BRUNSWICK STEAM ELECTRIC PLANT, UNIT NOS. 1 AND 2
DOCKET NOS. 50-325 AND 50-324
LICENSE NOS. DPR-71 AND DPR-62
SUPPLEMENTAL INFORMATION -
TMI ITEMS I.A.2.1 & II.B.4

CAROLINA POWER & LIGHT COMPANY'S (CP&L) RESPONSE TO UPGRADED SRO AND RO TRAINING AND TRAINING FOR MITIGATING CORE DAMAGE - NRC REQUEST FOR ADDITIONAL INFORMATION (APRIL 2, 1982)

Figure 1

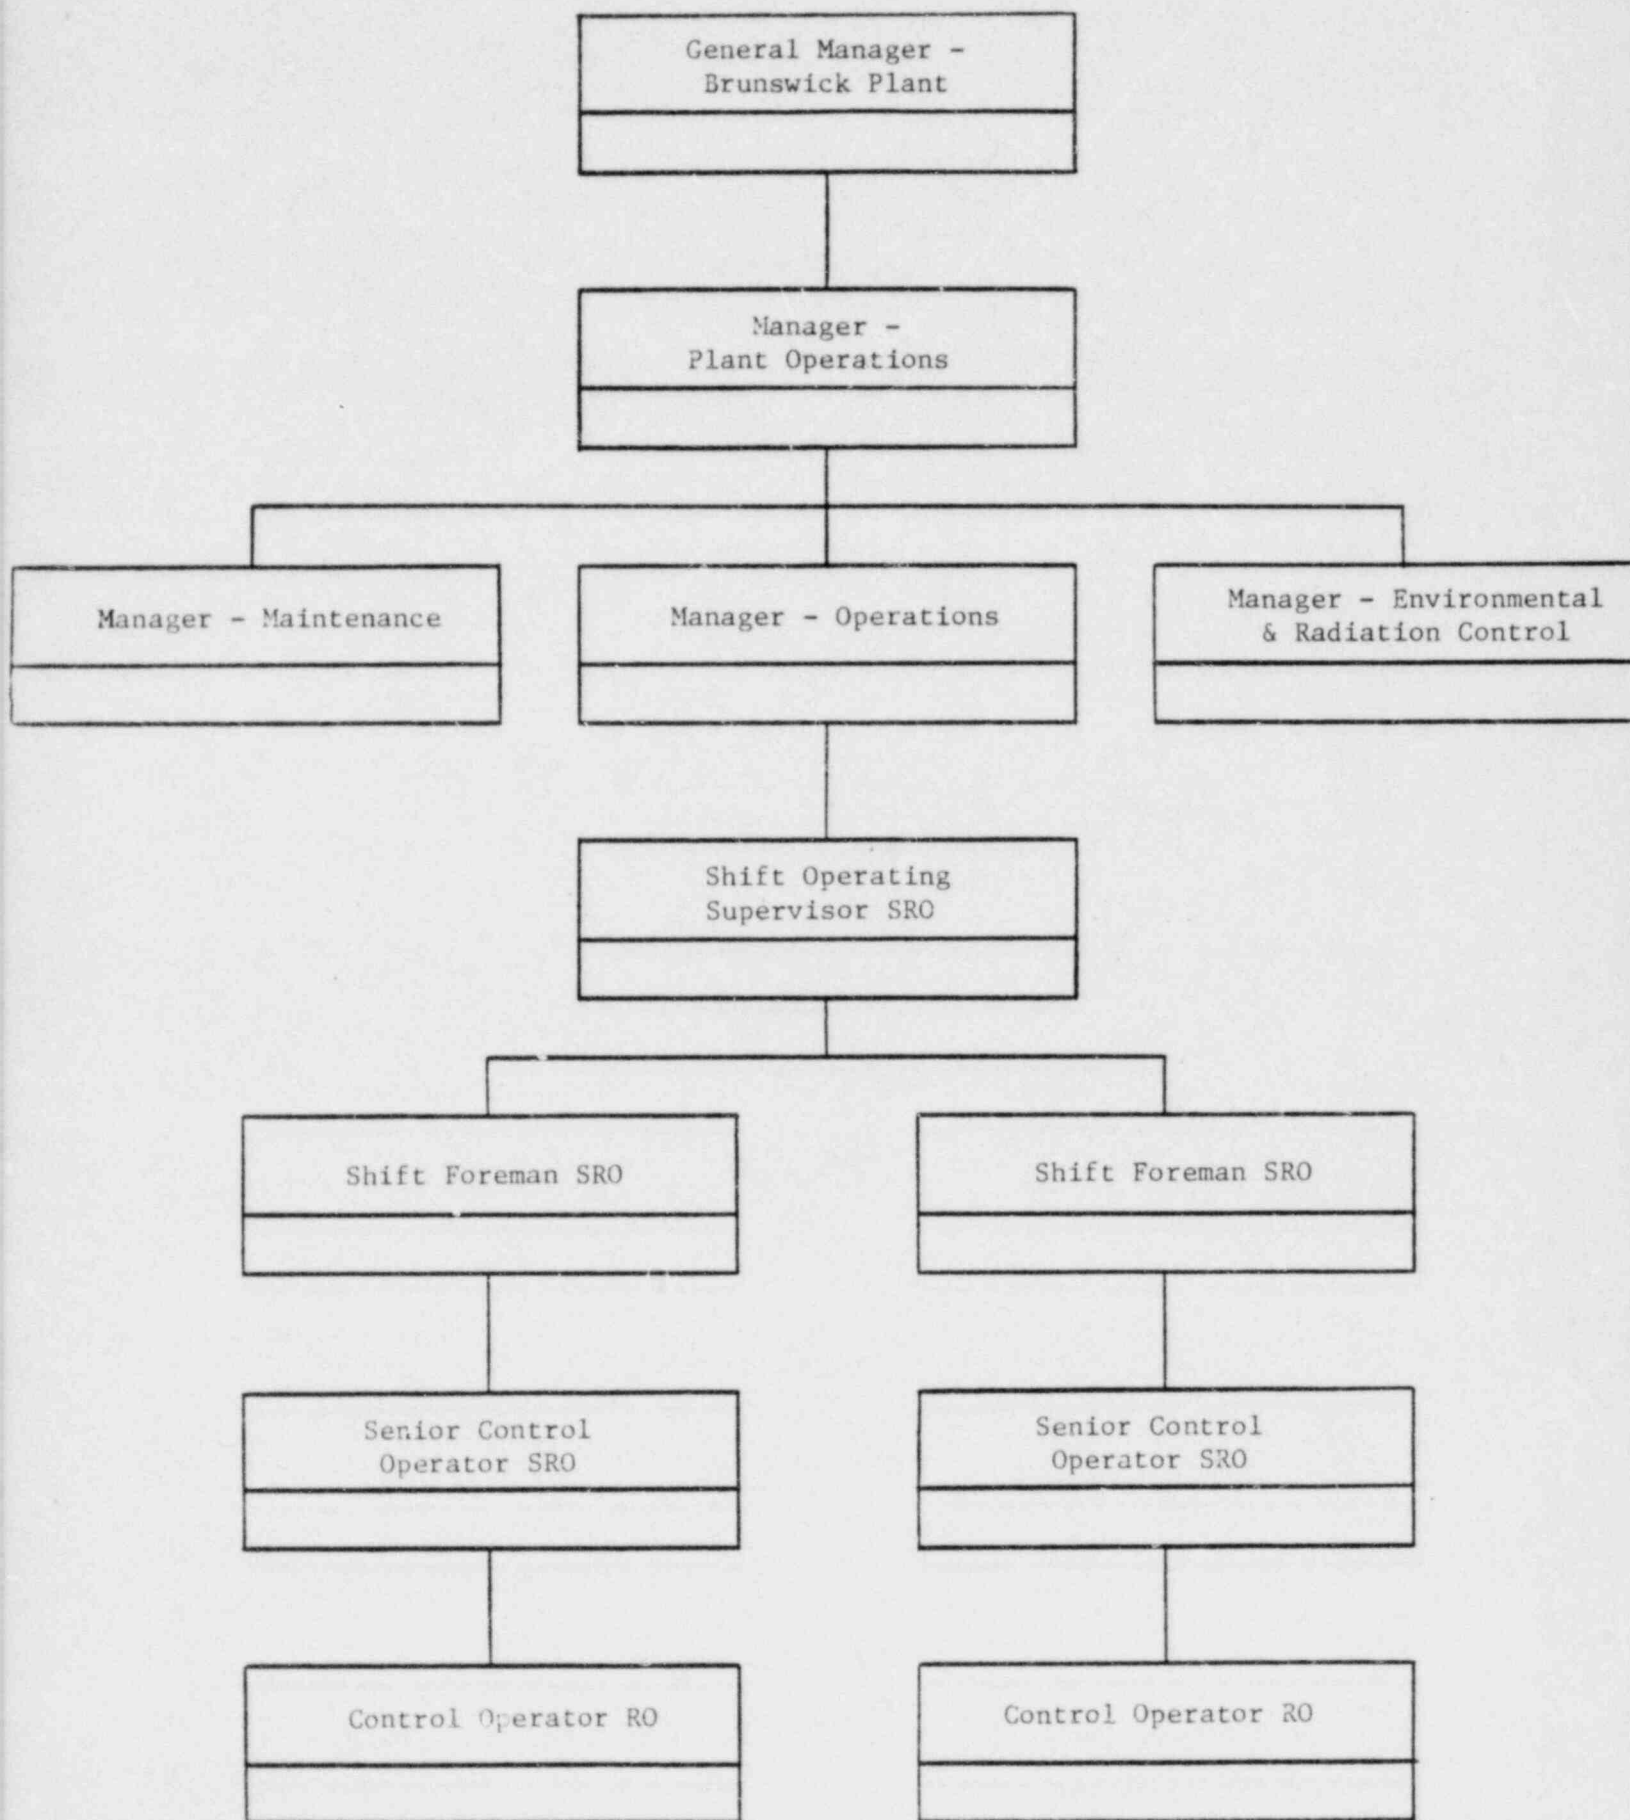
Are the lectures and quizzes on the subject of accident mitigation given to shift technical advisors and operating personnel from plant manager through the operations chain to the licensed operators? If they are, would you please provide the titles of the people who are trained and an organization chart which illustrates their position in the operations chain?

Lectures and tests regarding Accident Mitigation have been given to the following:

- * a) Shift Technical Advisors
- * b) Shift Operating Supervisors
- * c) Shift Foremen
- * d) Senior Control Operators
- * e) Reactor Operators
- * f) All licensed non-operations personnel
- * g) Manager - Operations

- t** h) Manager - Plant Operations
- t i) Manager - Maintenance
- t j) Manager - Environmental & Radiation Control
- t** k) General Manager

Figure 1 indicates management positions in the operating chain that received the training.
